# Product Change Notification

Product Group: SIL/Mon Sep 28, 2020/PCN-SIL-0362020-2020-REV-0

## Commercial Power MOSFET Manufacturing Capacity Expansion

### TO-247AC Outline

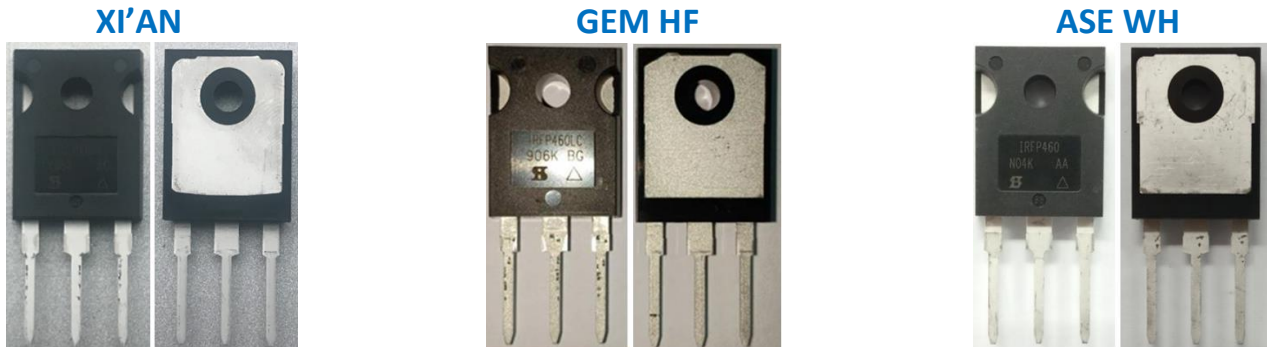
**EXPECTED INFLUENCE ON QUALITY/RELIABILITY/PERFORMANCE:** There will be no affect on the quality, reliability, or performance. There will be no changes in minimum and maximum values on the data sheets. The finished good appearance and outline dimension variance are shown in annex.

TO247AC Symbol	JEDEC		XI'AN		GEM HF		ASE WH		Change (GEM vs. ASE)
	Min	Max	Min	Max	Min	Max	Min	Max	
A	4.65	5.31	4.65	5.31	4.83	5.21	4.65	5.31	-0.18 / +0.10
A1	2.21	2.59	2.21	2.59	2.29	2.55	2.21	2.59	-0.08 / +0.04
A2	1.50	2.49	1.17	1.37	1.50	2.49	1.17	1.37	-0.33 / -1.12
b	0.99	1.40	0.99	1.40	1.12	1.33	0.99	1.40	-0.13 / +0.07
b1	0.99	1.35	0.99	1.35	1.12	1.28	0.99	1.35	-0.13 / +0.07
b2	1.65	2.39	1.65	2.39	1.91	2.39	1.65	2.39	-0.26 / +0.00
b3	1.65	2.34	1.65	2.34	1.91	2.34	1.65	2.34	-0.26 / +0.00
b4	2.59	3.43	2.59	3.43	2.87	3.22	2.59	3.43	-0.28 / +0.21
b5	2.59	3.38	2.59	3.38	2.87	3.18	2.59	3.38	-0.28 / +0.20
c	0.38	0.89	0.38	0.89	0.55	0.69	0.38	0.89	-0.17 / +0.20
c1	0.38	0.84	0.38	0.84	0.55	0.65	0.38	0.84	-0.17 / +0.19
D	19.71	20.70	19.71	20.70	20.40	20.70	19.71	20.70	-0.69 / +0.00
D1	13.08	–	13.08	–	16.25	16.85	13.08	–	-3.17 / none
D2	0.51	1.35	0.51	1.35	0.56	0.76	0.51	1.35	-0.05 / +0.59
E	15.29	15.88	15.29	15.87	15.50	15.87	15.29	15.87	-0.21 / +0.00

E1	13.46	–	13.46	–	13.46	14.16	13.46	–	+0.00 / none
e	5.46		5.46 BSC		5.46 BSC		5.46 BSC		None
Ø K	0.25		0.254		–		0.254		None
L	14.20	16.10	14.20	16.10	14.90	15.40	14.20	16.10	-0.70 / +0.70
L1	3.71	4.29	3.71	4.29	3.96	4.16	3.71	4.29	-0.25 / +0.13
N	–		7.62 BSC		–		7.62 BSC		None
Ø P	3.56	3.66	3.56	3.66	3.56	3.65	3.56	3.66	+0.00 / +0.01
Ø P1	–	7.39	–	7.39	–	7.19	–	7.39	none / +0.20
Q	5.69	5.82	5.31	5.69	5.31	5.69	5.31	5.69	None
R	4.52	5.49	4.52	5.49	4.52	5.49	4.52	5.49	None
S	5.51		5.51 BSC		5.54	5.74	5.51 BSC		None
